Access Compliance Report

Public Rights-of-Way

Intersection ID: N/A	Main Street: ROCKY_RIVER_RD	Cross Street: JOHN_RUSSELL_RD	Location: SW
ADA ID: 0FD067CD0C08	Ramp Type: Perp	Initial Pass/Fail: Fail	Overall Compliance: No
Severity Score: 12.5			
Codes/Mitigation Info/Possible Solution		Field Measurements/Component Compliance

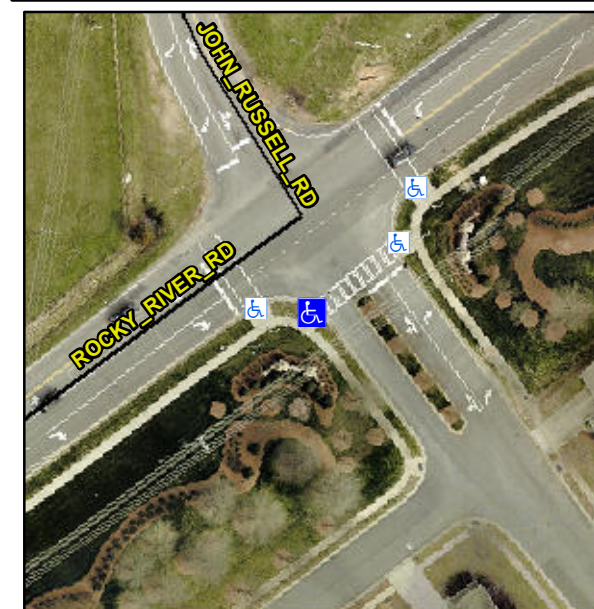
Not Found, R304.2.2

Compliance	Description	Data	Compliance	Description	Data
N/A	Ramp Length (in)	93.0	No	Ramp Slope (%)	10.4
Yes	Ramp Width (in)	48.0	Yes	Ramp XSlope (%)	0.5
N/A	Flare Type LT	N/A	N/A	Flare Type RT	N/A
N/A	Flare Slope LT (%)	N/A	N/A	Flare Slope RT (%)	N/A
N/A	Flare Traversable LT?	N/A	N/A	Flare Traversable RT?	N/A
N/A	Landing Length (in)	N/A	N/A	DWS Provided?	N/A
N/A	Landing Width (in)	N/A	N/A	DWS Contrast?	N/A
N/A	Landing Slope (%)	N/A	N/A	DWS Length (in)	N/A
N/A	Landing X Slope (%)	N/A	N/A	DWS Full Width?	N/A
N/A	Landing Curb? (Y/N)	N/A	N/A	DWS Offset (in)	N/A
N/A	Shared Landing?	N/A			
N/A	Gutter Ponding?	N/A	N/A	Gutter Slope (%)	N/A
N/A	Gutter Lip Ht (in)	N/A	N/A	Gutter X Slope (%)	N/A
N/A	Painted X Walk1?	Yes	N/A	Painted X Walk2?	N/A
	X Walk 1 Direction	To E		X Walk 2 Direction	N/A
N/A	X Walk 1 Width (in)	110.0	N/A	X Walk 2 Width (in)	N/A
	X Walk 1 Slope (%)	1.3		X Walk 2 Slope (%)	N/A
	X Walk 1 X Slope (%)	0.9		X Walk 2 X Slope (%)	N/A

Remove & Replace Entire Ramp.
